The Commission has issued the enclosed Amendment No. 84 to Facility Operating License No. DPR-23 for the H. B. Robinson Steam Electric Plant Unit No. 2. This amendment consists of changes to the Technical Specifications in response to your requests dated October 31, 1983 and superseded on April 26, 1984.

The amendment would revise the Technical Specifications, Administrative Controls, Section 6, to reflect corporate organizational changes.

Amendment No. 84
License No. DPR-23

AMENDMENT NO. 84 FACILITY OPERATING LICENSE NO. DPR-23

H. B. ROBINSON UNIT #2
Carolina Power & Light Company
OFFSITE ORGANIZATION & FACILITY MANAGEMENT
Figure 6.2-1

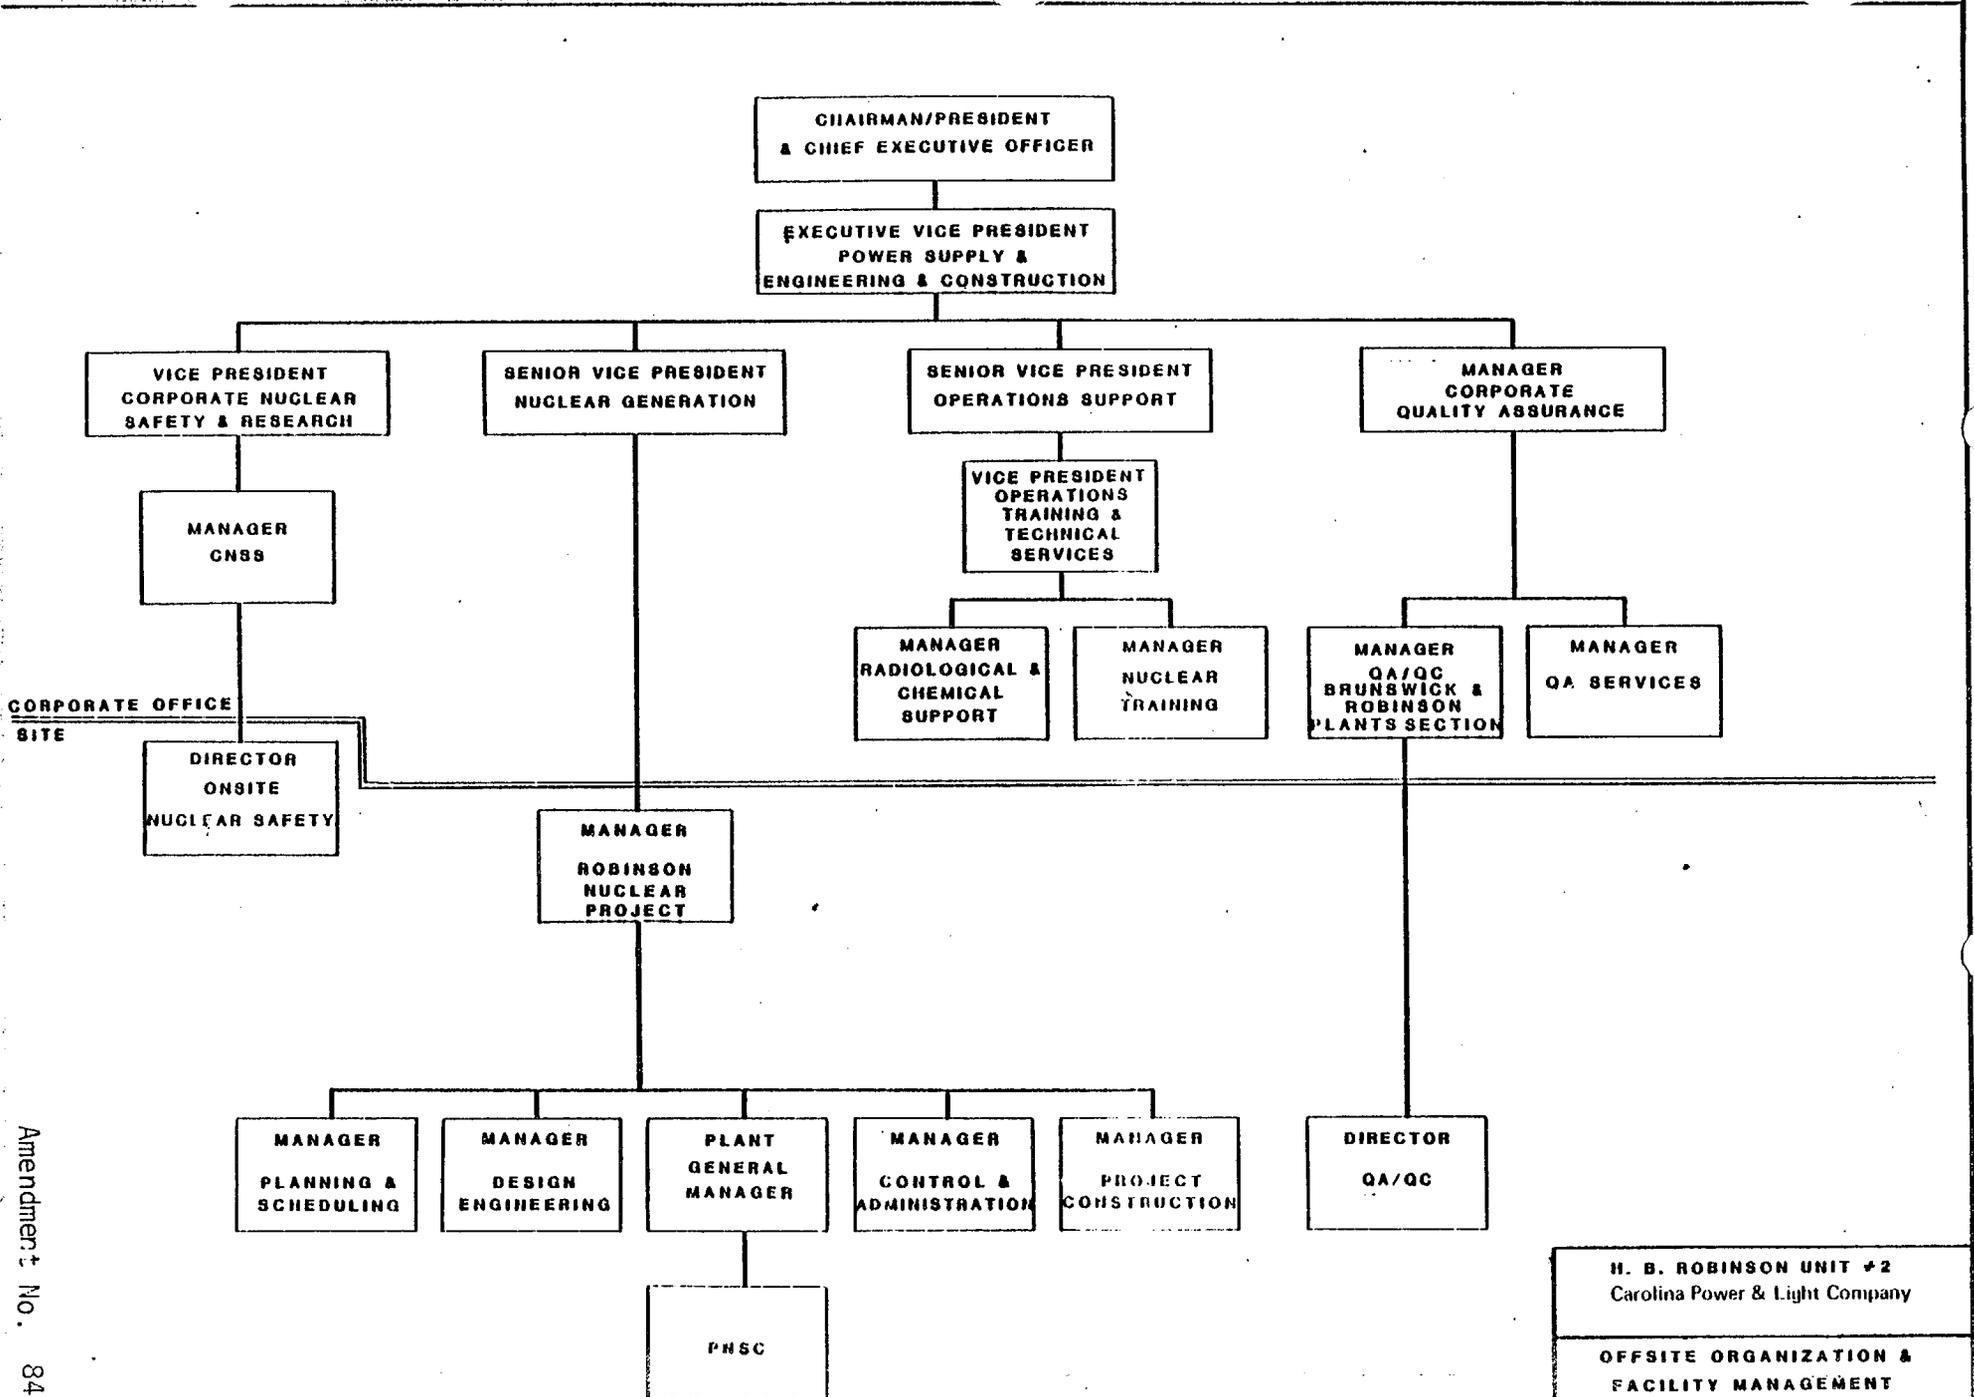
6.2.1 The offsite organization for facility management and technical support shall be as shown on Figure 6.2-1.

FACILITY ORGANIZATION
 ROBINSON NUCLEAR PROJECT
 Figure 6.2-2

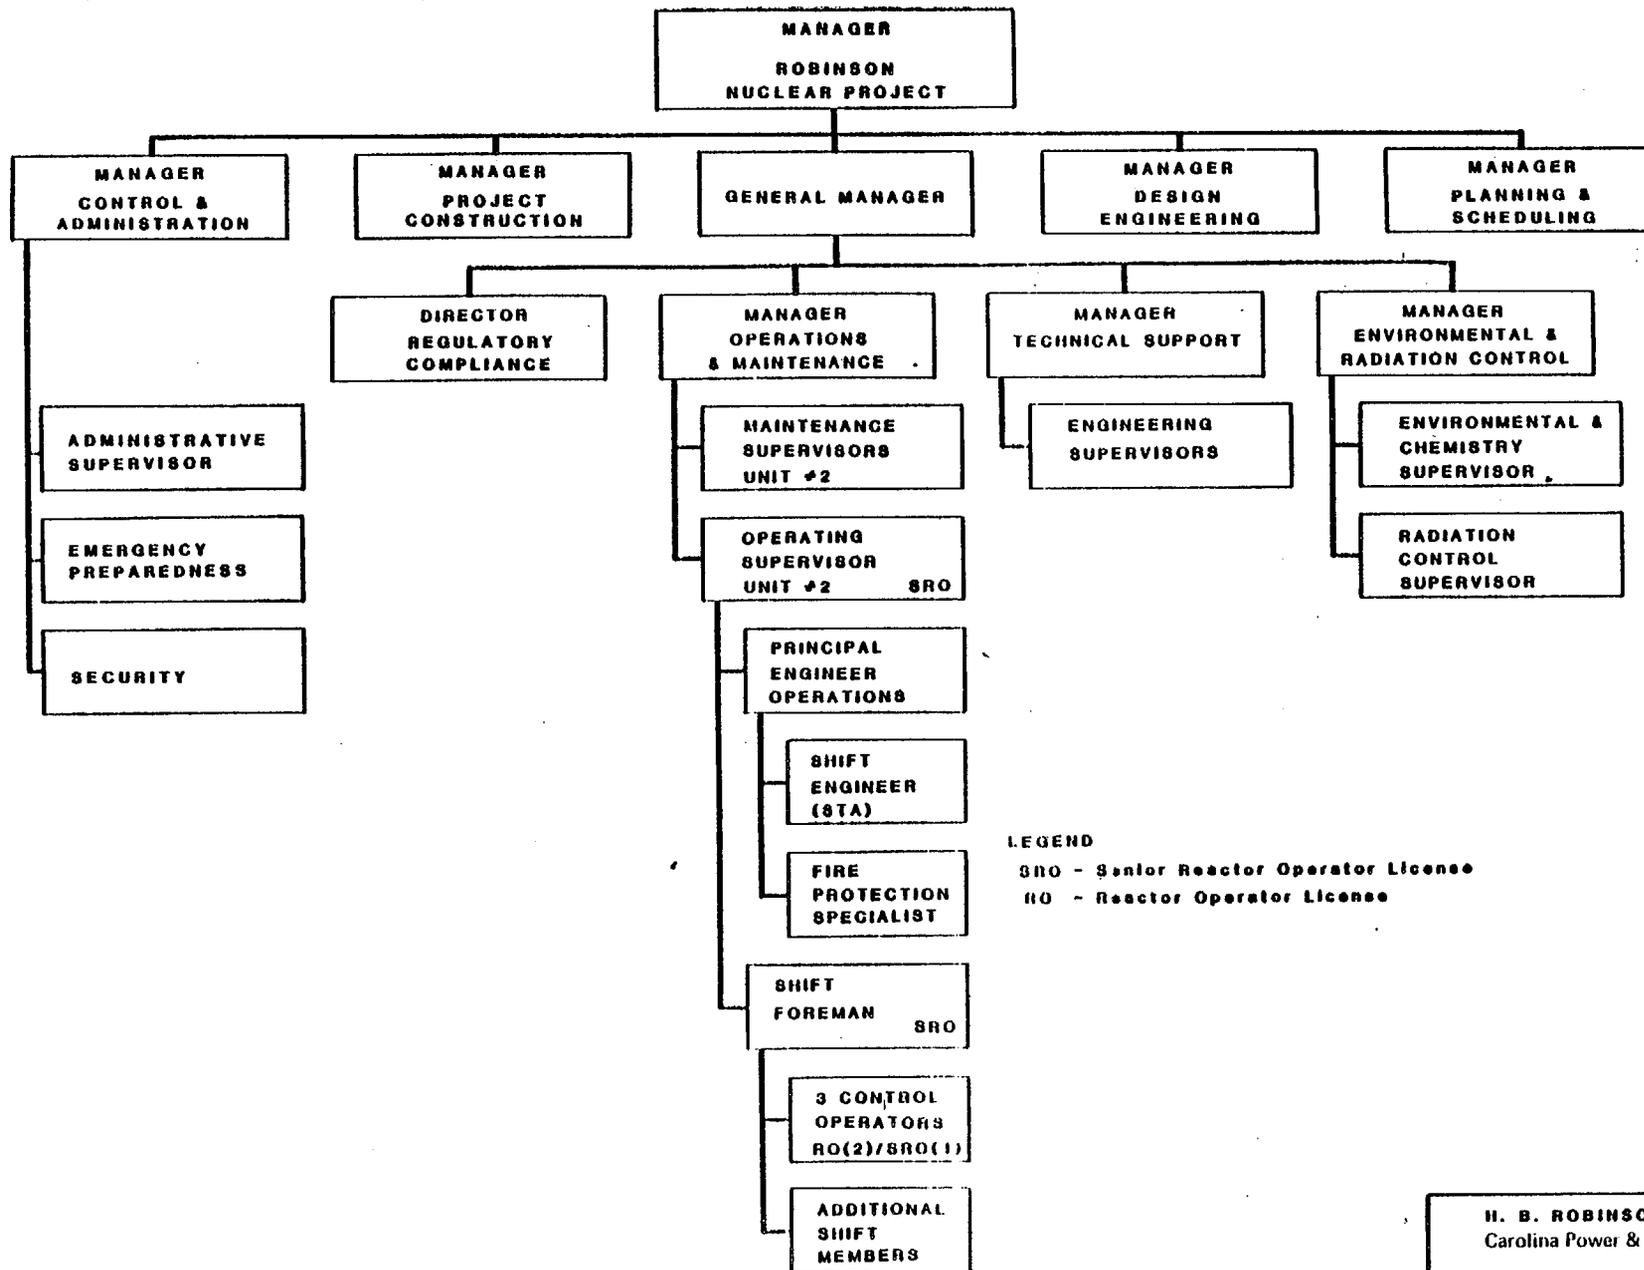
6.2.3 The Robinson Nuclear Project organization shall be as shown in Figure 6.2-2 and:
